re: File No. PP13-085: Three Creeks Trail Pedestrian Bridge Project

I would like to submit the following questions and comments in response to the Initial Study and draft Mitigated Negative Declaration (IS/MND) for PP13-085: Three Creeks Trail Pedestrian Bridge Project. (Note: while I've been involved with a number of groups and agencies over the years that have been involved with creeks, trails, habitats, and historic preservation, the comments herein are my personal statements and not on behalf of any group.)

Fig. 1: Aerial view of trestle and power lines

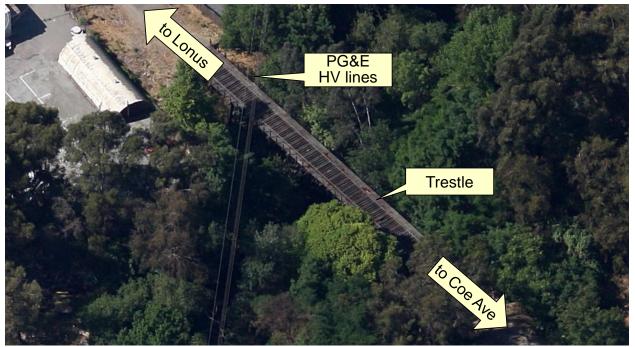
PG&E has a high-voltage power crossing over the trestle: see Fig. 1.

- What precautions will be taken to avoid accidental electrocution when using cranes to remove the existing trestle?
- What precautions will be needed to avoid electrocution when using cranes to install the pre-fabricated single-span steel truss directly beneath these high-voltage power lines?
- Has PG&E been consulted regarding the proposed actions?

Fig. 4: View of the Trestle from the planned Los Gatos Creek Trail

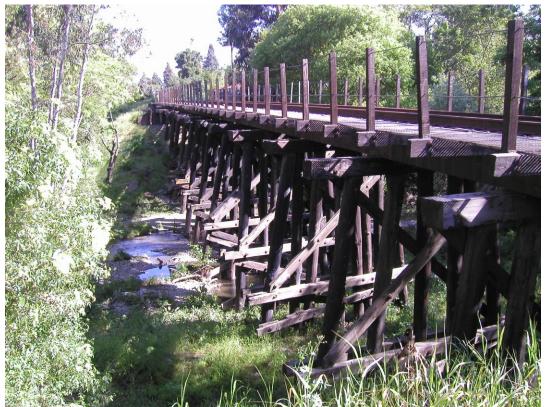
The IS/MND only discusses the view from the nearby residences, and then mainly during the construction phase: there is no mention of the trail-users' experience. The trestle intersects the planned extension of the Los Gatos Creek Trail. Trail users going south from downtown San José will cross under I-280 to the current terminus at Lonus Street, and then continue on a new trail behind the businesses and along the top-of-bank to the junction with the Three Creeks Trail –se Fig. 3. Figure 4 shows the view of the trestle from that point: it would be a fitting and iconic gateway to Willow Glen. As mentioned at the beginning of this letter, the 1920's trestle gives a fitting welcome to the 1920's-era community of Willow Glen, a community whose very existence as an independent town in the 1920's is due to the impact of the railroad. (For background information, please see "Touring Historic Willow Glen –Ten Walking Loops", available at Hick-lebees and at the SJ History Park.)

• When evaluating "the existing visual character or quality of the site and its surroundings", why does the IS/MND only consider the impact on adjacent residents and views from state scenic highways, rather than also evaluating the impact on the users of the trail?

- What would be the experience of a trail user going southwest on the Los Gatos Creek Trail and coming up to the planned pre-fabricated steel-truss bridge?
- What would be the experience of a trail user going southwest on the Los Gatos Creek Trail and coming up to a restored wooden trestle that has been adapted for trail usage?
- Is Willow Glen better characterized as more of a "modern, bustling" district in San José or more of a "neighborhood village of the era between-the-Great-Wars"?
- Would a new pre-fabricated steel-truss bridge or a restored wooden trestle be more representative of the character of the Willow Glen district?
